ADDENDUM NO. 2

PROJECT NO. DGS C-0946-0012 PHASE 006

PROJECT TITLE - PA State Museum & PHMC Tower - Infrastructure Upgrades and Renovations

Design Resources Group Architects AIA
270 Davidson Ave, Suite 303
Somerset, NJ, 08873

DRAWING SET IS INTENDED FOR COLOR PRINTING

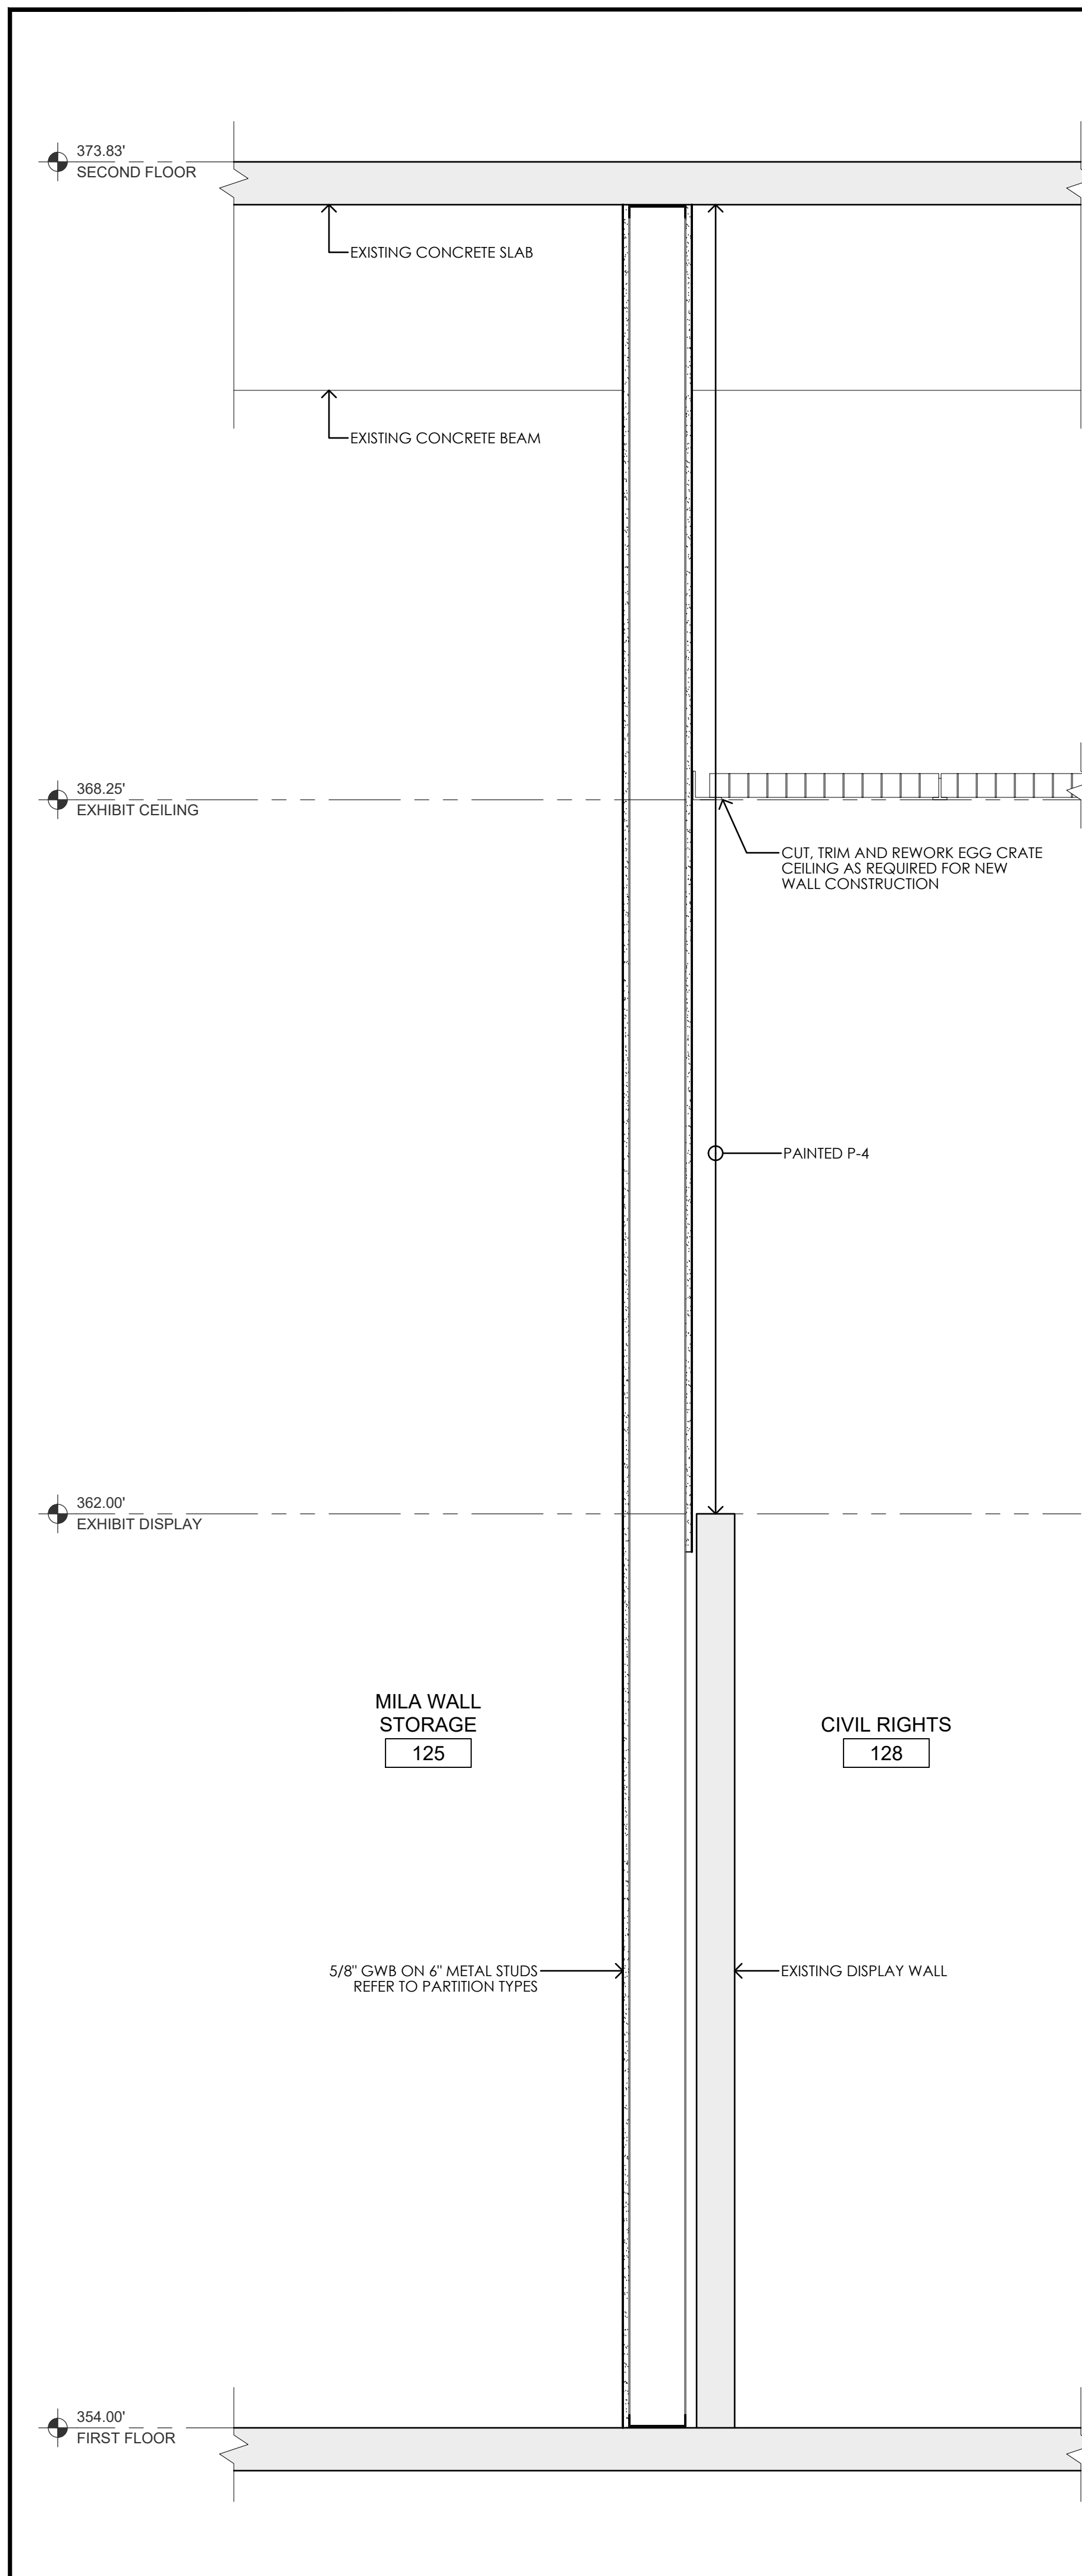
Item 26 - Drawing A410 - At Detail 47, corrected detail reference to 29/A424.
